**Model : Breva 750**

**Subject: Side bags**

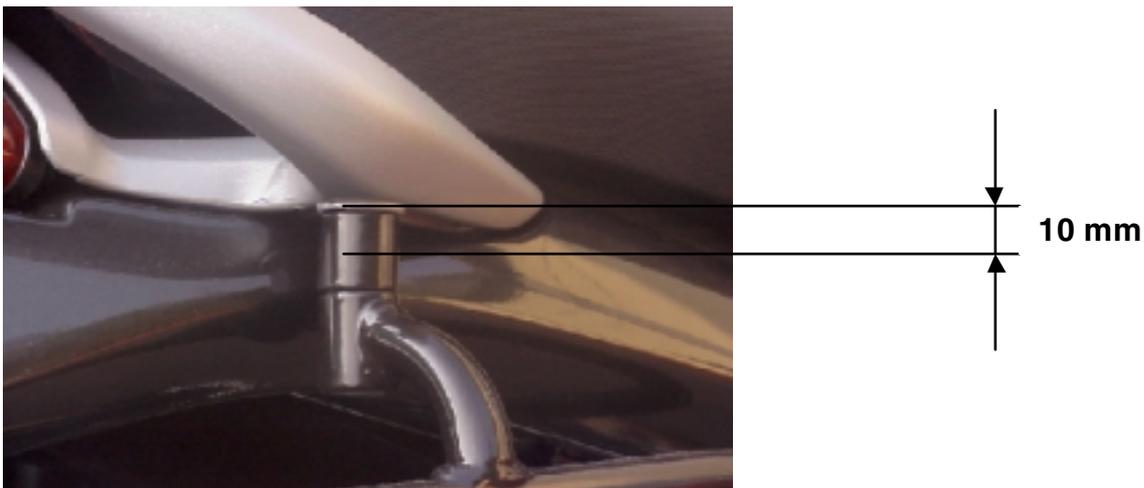
After mounting the side bag attachments, it is necessary to check that the distance between the top of the silencer and the bottom of the bag is 15 mm at least.

Should this minimum distance of 15 mm not be complied with, the bags could be damaged due to the heat produced by the exhaust fumes.

If this distance is shorter, it is possible to lift the bag attachments by shortening of 10 mm the bushes placed between the attachments and the bike frame.
